DEPARTMENT OF TRANSPORTATION - District 4 Toll Bridge Program

Contract No. 04-0120F4
04-SF-80-13.2 / 13.9
Self-Anchored Suspension Bridge
Letter No. 05.03.01-000551

Project Schedule Revision for August 2007

The Department has completed review of Submittal ABF-SUB-000269R00, "Project Schedule Monthly Update No. 11," dated August 24, 2007 with a data date of August 20, 2007.

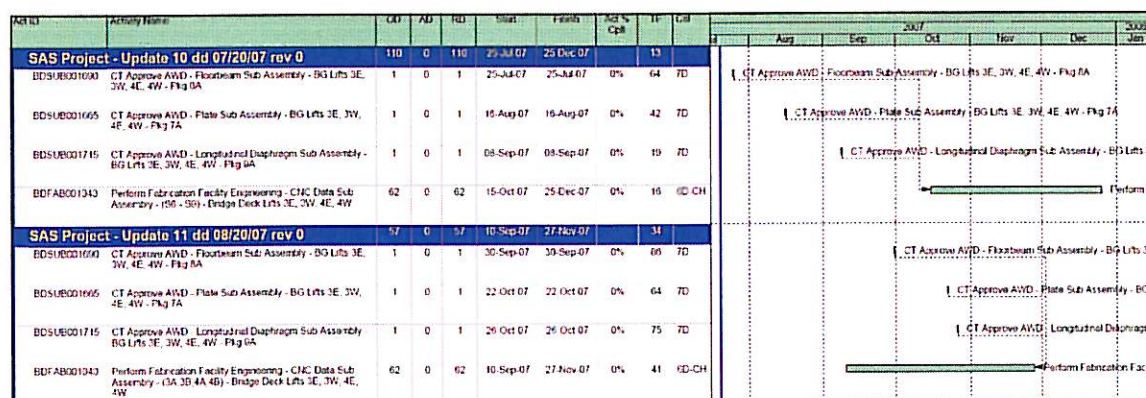
D13. As previously discussed, the “*Perform Fabrication Facility Engineering - CNC Data...*” activities appear to have unnecessarily long durations. Some as long as 101 days. Originally these activities were scheduled to have a finish to start relationship (FS) with activities “*CT review AWD...*” The majority of the facility engineering CNC data activities can be started long before Caltrans reviews are complete. This is evidenced by recent changes in the logic of some of these types of activities (See the schedule clip below showing the revision of the FS relationships with a Finish to Finish relationship with a 20 day lag). Why are some of these relationships revised? Why not change all of these relationships to more appropriately model the work? See the schedule clip below showing a net savings of approximately 72 days on the OBG fabrication path.
